Delegated Report

Householder Planning Application

Planning Application No: 20220933

Location: 3 Stacey Close Gravesend Kent DA12 5TD

Proposed Side Elevation

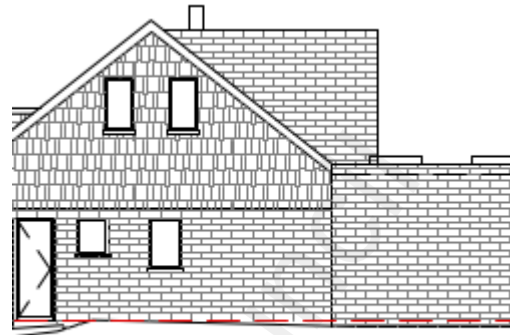
The application for the single storey side extension proposes a flat roof. Gravesham's Householder Design Guide states that side extensions should incorporate roof designs to reflect the main property's roof and the use of flat roofs should be avoided. In this instance it is noted that the side extension would be set well back from the road and therefore would be unreasonable to refuse the application on these grounds.

Gravesham's Householder Design Guidance states that a single storey side extension should consider the impact on the character and appearance of the host building. Whilst it is acknowledged that there is an existing single storey rear extension with a height of 3.2m, any subsequent extensions should be designed in line with the guidance and be subservient. The proposed side extension is not set down from the main roof and would dramatically interrupt the eaves of the roof, visible from the street scene.

As such, the proposed extension is not sympathetic in design to the existing dwellinghouse and therefore would be contrary to Gravesham's Householder Extensions/Alterations Design Guidance SPD (2021) and the proposal would be contrary to Policy CS19 of the Core Strategy and paragraph 130 of the NPPF (2021).

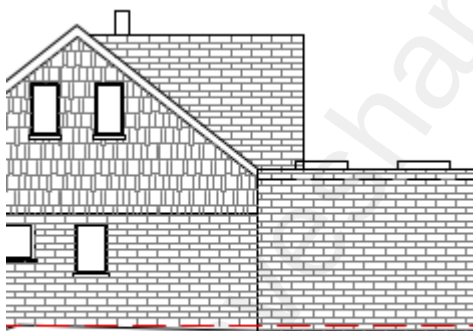
The rear dormer extension with part two storey section looks to create space for a larger bedroom and dressing room area. The proposed dormer would have a height of 2.65m, a width of 6.58m and a depth of 4.3m. The dormer would include two windows to the rear elevation and be constructed with brick to match the existing dwellinghouse.

Gravesham's Householder Design Guidance states that rear roof extensions should be set away from the eaves of the property and should not overwhelm the roof space with which they are to be placed. As shown, the proposed dormer would not be set back from the eaves of the property. This would also be refused if applied for under permitted development:

SIDE ELEVATION 1

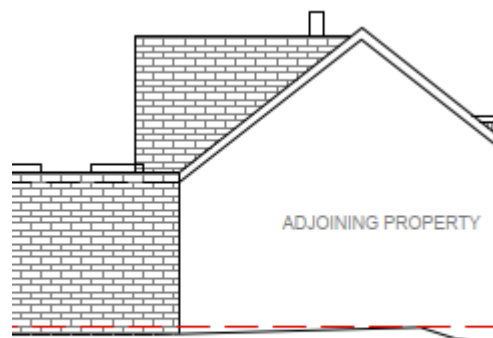
Due to the width, height and projection of the proposed dormer, the development takes on the appearance of a two storey, flat roof extension.

Therefore, the proposed dormer is contrary to Policy CS19 of the Gravesham Local Plan Core Strategy 2014 and paragraph 130 of the National Planning Policy Framework (2021).
